AUDUBON COVE SUBDIVISION, RESUBDIVISION OF LOTS 8 & 9

APPLICATION NUMBER 7 DATE August 4, 2011

REQUEST Subdivision

DETAIL SITE PLAN

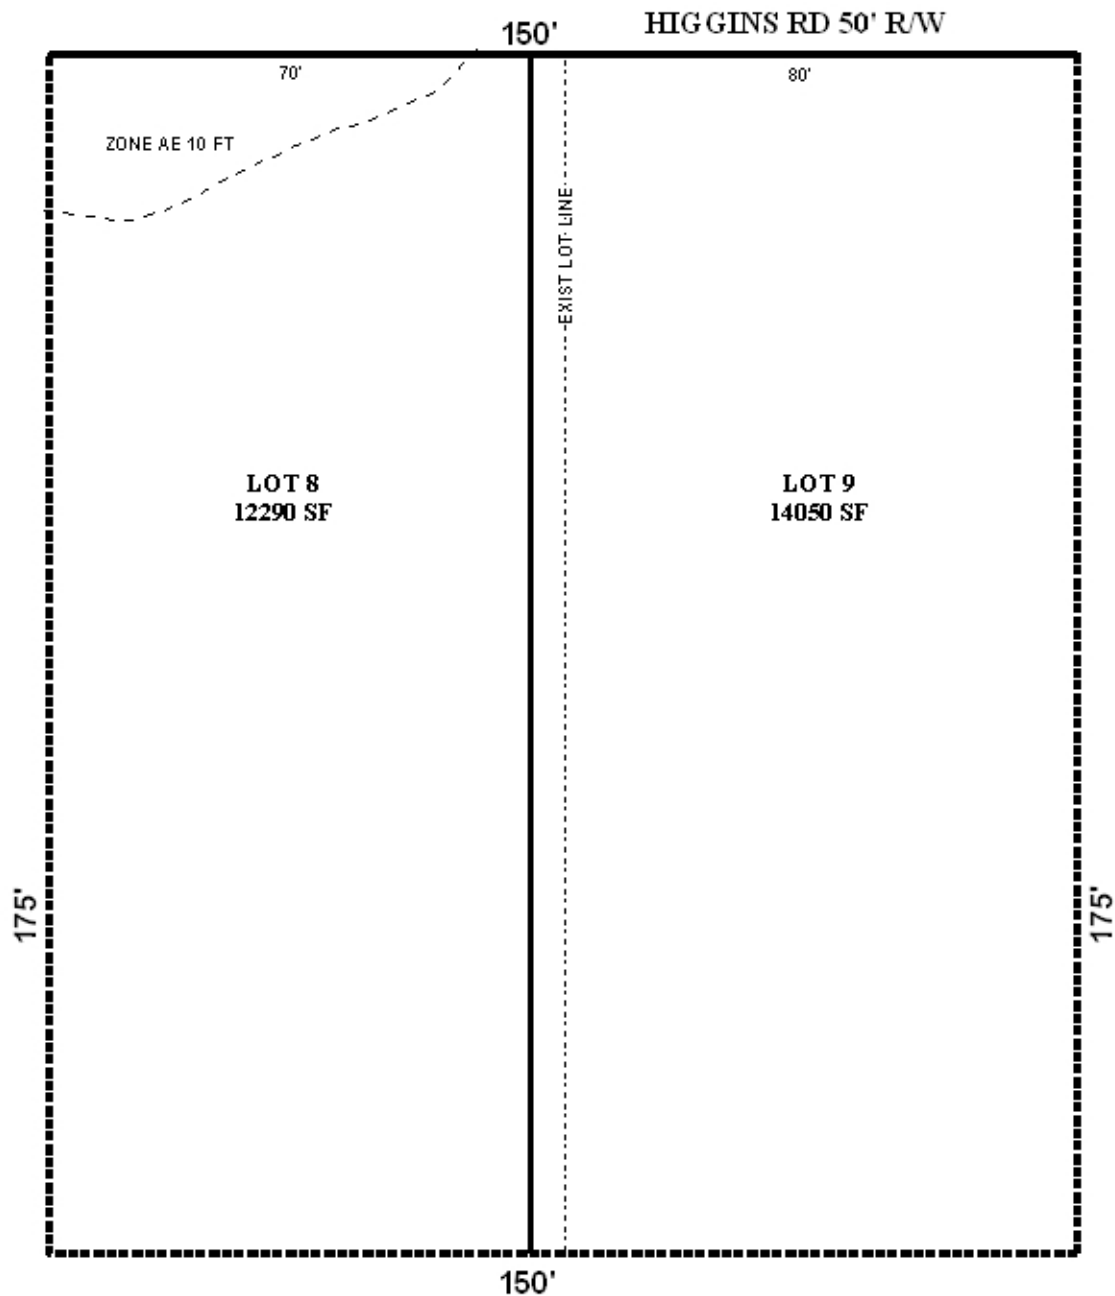
As proposed, Lot 8 would decrease in width from 75' to 70' and Lot 9 would increase in width from 75' to 80'. Both lots would meet the minimum lot size requirements of the Subdivision Regulations. However, the plat should be revised to label each lot with its size in both square feet and acres, or a table should be furnished on the final plat providing the same information. The plat should also be revised to illustrate the 25' minimum building setback line along Higgins Road. Since Higgins Road has a compliant 50' right-of-way, no dedication would be required. As a means of access management, a note should be required on the Final Plat stating that each lot is limited to one curb cut to Higgins Road, with size, location and design to be approved by Traffic Engineering and conform to AASHTO standards.

- 1) revision of the plat to label each lot with its size in acres and square feet, or the furnishing of a table on the final plat providing the same information;

- 2) revision of the plat to illustrate the 25' minimum building setback line along Higgins Road;
- 3) placement of a note on the Final Plat stating that each lot is limited to one curb cut to Higgins Road, with the size, location and design to be approved by Traffic Engineering and conform to AASHTO standards;

- 4) placement of a note on the Final Plat stating that the approval of all applicable federal, state and local agencies would be required for floodplain and wetland issues prior to the issuance of any permits or land disturbance activities;

- 5) placement of a note on the Final Plat stating that development of this site must be undertaken in compliance with all local, state, and Federal regulations regarding endangered, threatened or otherwise protected species; and

- 6) subject to the Engineering Comments: *(Show Minimum Finished Floor Elevation on each lot on Plat. There is to be no fill placed within the limits of the flood plain without providing compensation. Must comply with all storm water and flood control ordinances. Any work performed in the right of way will require a right of way permit in addition to any required land disturbance permit. Drainage from any dumpster pads cannot discharge to storm sewer; must have connection to sanitary sewer).*
